REVISION SUMMARY #1

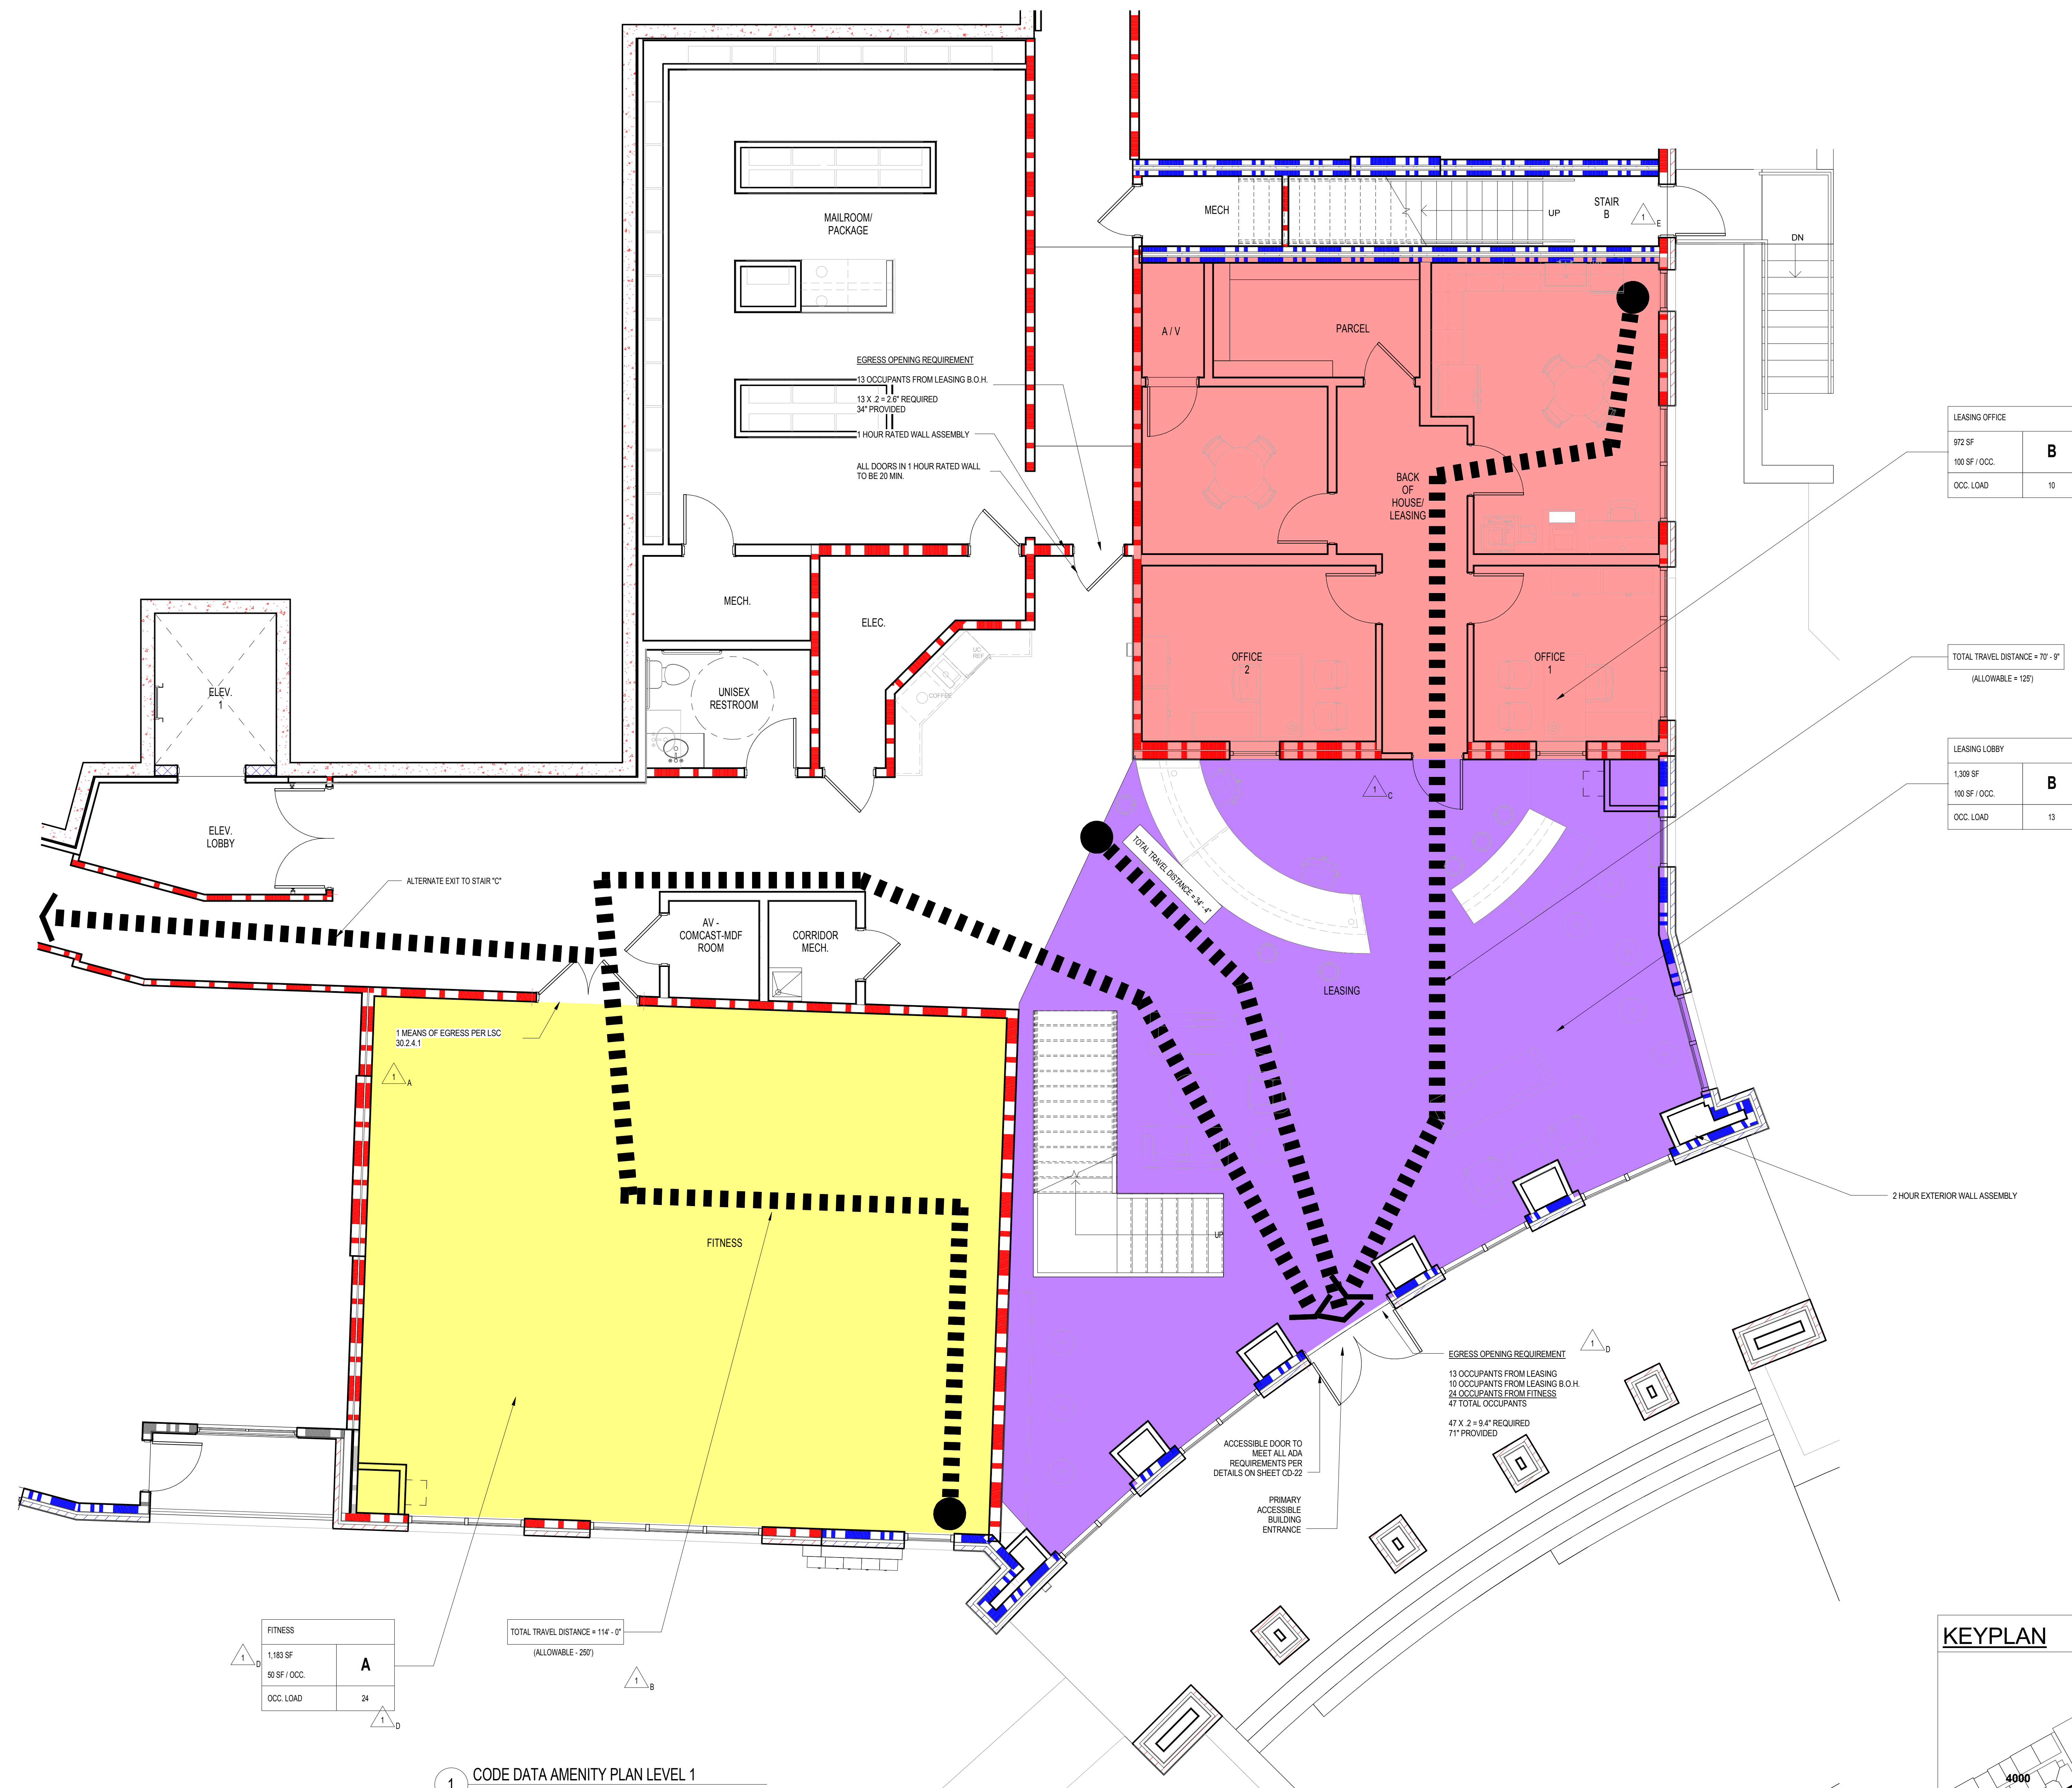
- A. REMOVED REFERENCE TO IBC. REFERENCED APPLICABLE LSC SECTION
- B. REVISED TRAVEL PATH & DISTANCE
- C. DOOR SWING CHANGED TO FOLLOW EXIT TRAVEL PATH
- D. REVISED OCCUPANT LOAD
- E. REVISED STAIR LABELS TO ALPHA CHARACTERS
